From: Brad Harvey
Sent: Wednesday, April 02, 2008 3:09 PM
To: STPCOL
Subject: FW: Preliminary Questions in Chapter 2 of the STP COLA
Attachments: Preliminary list of information needs relative to the STP COLA FSAR Chapter 21.doc; Site Audit Findings.doc

From: Raj Anand
Sent: Tuesday, March 11, 2008 11:29 AM
To: dwstillwell@stpegs.com; gtgibson@stpegs.com; wemookhoek@STPEGS.COM
Cc: Hosung Ahn; Brad Harvey; Belkys Sosa; Mark Tonacci; Seshagiri Tammara; STPCOL; George Wunder
Subject: Preliminary Questions in Chapter 2 of the STP COLA

Preliminary Information Needs for the STP Safety Site Audit

**Resolution of Preliminary Information Needs
STP Safety Site Audit
March 25-27, 2007**

Figure 1
STP Stability Class Frequency Distributions

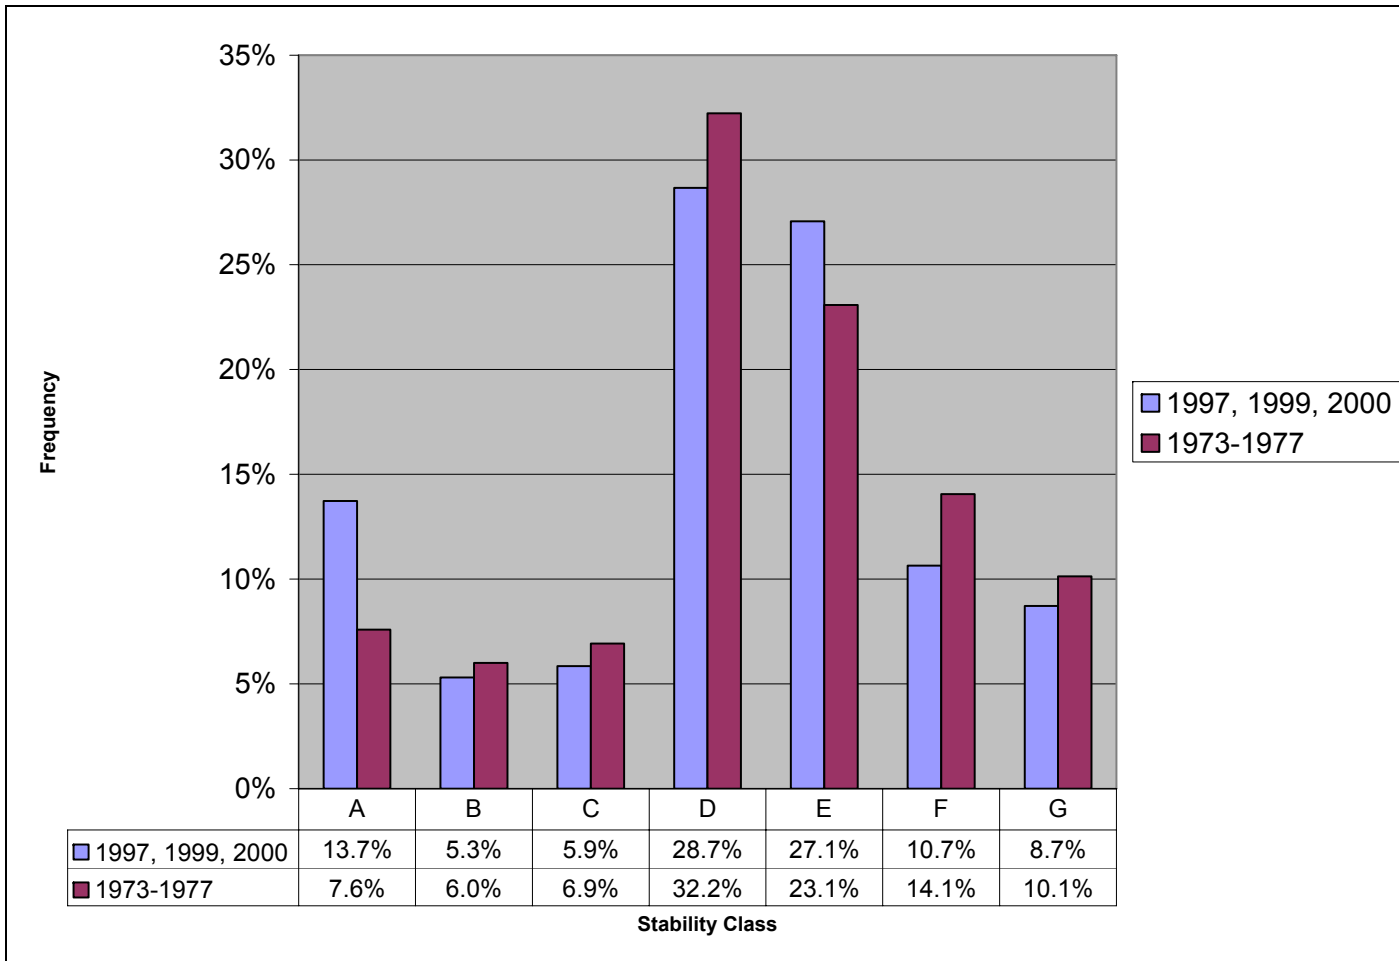
23.	2.3S3.4.1.2	Meteorology	Please explain the 6% increase of onsite A stability class frequency from the original data set (1973-1977) to the current (1997, 1999, and 2000) data set as shown in FSAR Table 2.3S-20 (see Figure 1).	Brad Harvey
